Project	IEEE 802.16 Broadband Wireless Access Working Group < http://ieee802.org/16 >	
Title	Proposed Modification on Protocol Functionalities for Supporting IEEE 802.16m E-MBS	
Date Submitted	2008-1-16	
Source(s)	Chun-Yen Wang, ITRI Richard Li, ITRI Chun-Yuan Chiu, ITRI Chie-Ming Chou, ITRI Fang-Ching (Frank) Ren, ITRI Wern-Ho sheen, NCTU/ITRI	Voice: E-mail: ChunYen@itri.org.tw richard929@itri.org.tw
Re:	IEEE 802.16m-07/047 - Call for Contributions on Project 802.16m System Description Document (SDD), shoot for "Proposed IEEE 802.16m Protocol Architecture and main functionalities per protocol layer" topic.	
Abstract	This contribution proposes some modifications on protocol functionalities from supporting E-MBS point of view.	
Purpose	For discussion and approval by TGm	
Notice	<i>This document does not represent the agreed views of the IEEE 802.16 Working Group or any of its subgroups. It represents only the views of the participants listed in the "Source(s)" field above. It is offered as a basis for discussion. It is not binding on the contributor(s), who reserve(s) the right to add, amend or withdraw material contained herein.</i>

Proposed Modification on Protocol Functionalitie

Fig. 1. IEEE 802.16 Protocol Layer

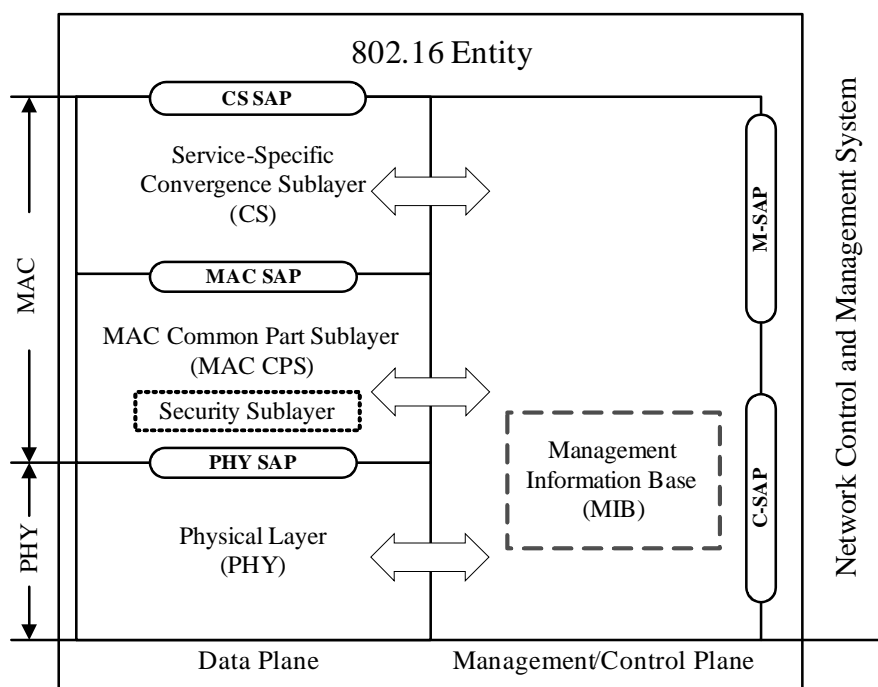
The proposed IEEE 802.16m protocol architecture is similar to that of the existing 802.16 system as shown in Fig. 1 with some modifications as described in the following.

classification and payload header compression (PHS). However, we suggest that PHS (if required) shall be done in the ASN gateway when transmitting E-MBS services. On one hand, we can save many efforts to maintain the header compression context synchronized between multiple BSs to achieve macro diversity transmission; on the other hand, if the PHS is performed in ASN gateway, there is only one compressor context per E-MBS service, so MS's decompressor context can keep the same when moving into a new cell. Therefore, performing PHS in ASN gateway for E-MBS transmission can save handover interruption time and reduce extra implementation complexity.

Most functionality of the MAC Common Part Sublayer (MAC CPS) and Physical layer in single-BS access are kept the same as that for unicast transmission so as to maintain the maximum commonality between E-MBS and unicast transmission. But for MBSFN transmission mode, multiple BSs are mandatory to transmit the same signal at the same time/frequency resource. Therefore, some management operations, such as data scheduling and resource allocation in the MAC CPS layer, and adaptive modulation and coding (AMC) schemes in the PHY layer, shall be controlled by a centralized coordination entity (i.e., MBS server).

Proposal 1: The Service-Specific Convergence Sublayer performs payload header compression (PHS) (if required) except for E-MBS transmission.

Proposal 2: The MAC Common Part Sublayer shall perform data scheduling and resource allocation except for MBSFN transmission.

Proposal 3: The PHY shall adaptively select a suitable radio configuration (e.g., modulation and code rate) except for MBSFN transmission.
